NOTES ON THE NEW DESIGNED SOCKET CONTACT:

TITLE:  
**OLD & NEW SOCKET CONTACTS COMPARISON**

DRAWING No.  
**51560083-132**

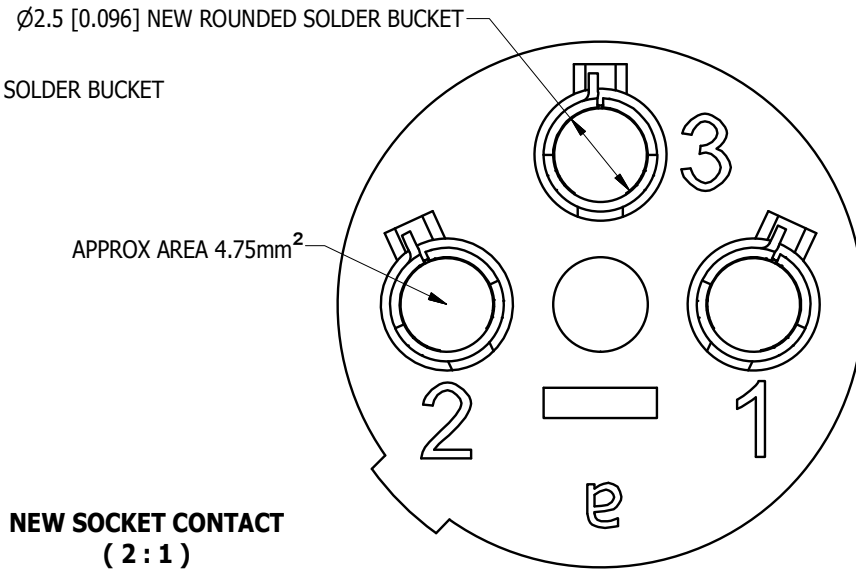
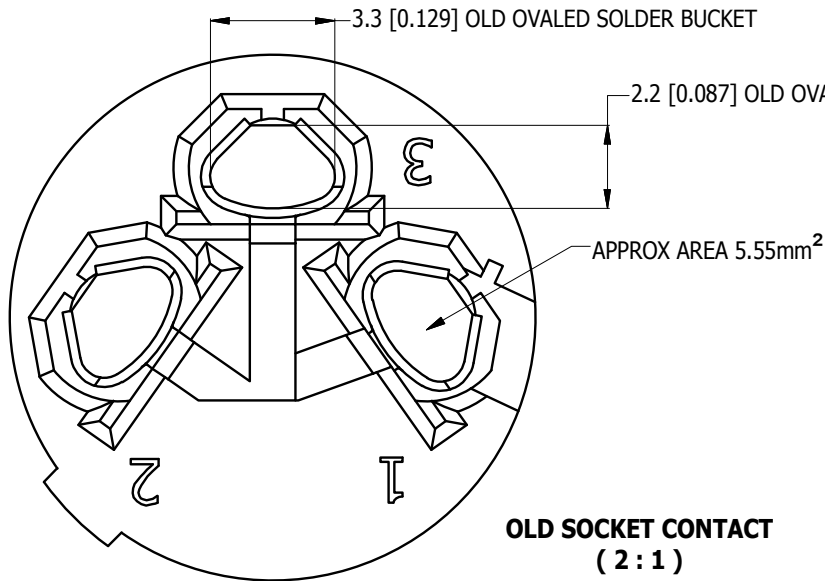
1. OLD OVALED SOLDER BUCKET IS REPLACED BY NEW ROUNDED SOLDER BUCKET,
2. NEW ROUNDED SOLDER BUCKET ELIMINATED THE EXTRA GAP AT BOTH ENDS OF THE OVALED SHAPE IN OLD SOLDER BUCKET.
3. NEW ROUNDED SOLDER BUCKET REQUIRE LESS SOLDER APPLIED REQUIRED TO SOLDER JOINS.
4. APPROX AREA REDUCED FROM 5.55mm<sup>2</sup> TO 4.75mm<sup>2</sup>.
